Access Compliance Report

Public Rights-of-Way

(Pedestrian Signals)

Intersection ID: N/A	Main Street:	Cross Street: N/A	Location: N/A
ADA ID: 5DEE9B443E22	Signal Type: Two Push Buttons-Non APS	Overall Compliance: No	Severity Score: BTN 1:N/A BTN 2: N/A No BTN: N/A
Codes/Mitigation Info/Possible Solution		Field Measurements/Component Compliance

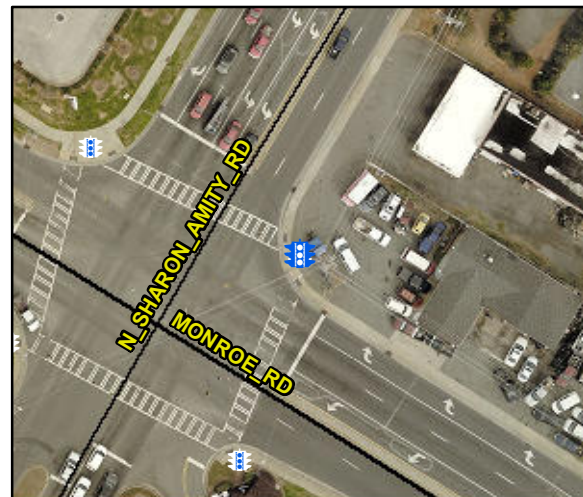
PROW/ADA: TMUTCD 4e.08, R404.2

Yes	B 1 Clear Xing Direction?	ClearlyMarked	Yes	B 2 Clear Xing Direction?	ClearlyMarked
	B 1 Crossing Direction	To NW		B 2 Crossing Direction	To SW
Yes	B 1 DistanceTo XWalk (in)	0.0	Yes	B 2 DistanceTo XWalk (in)	0.0
No	B 1 DistanceTo Curb (in)	116.0	No	B 2 DistanceTo Curb (in)	146.0
Yes	B 1 Diameter (in)	2.0	Yes	B 2 Diameter (in)	2.0

Possible Solutions: Replace Signal Push Button With APS Button on New Post. Remove & Relocate Sign.
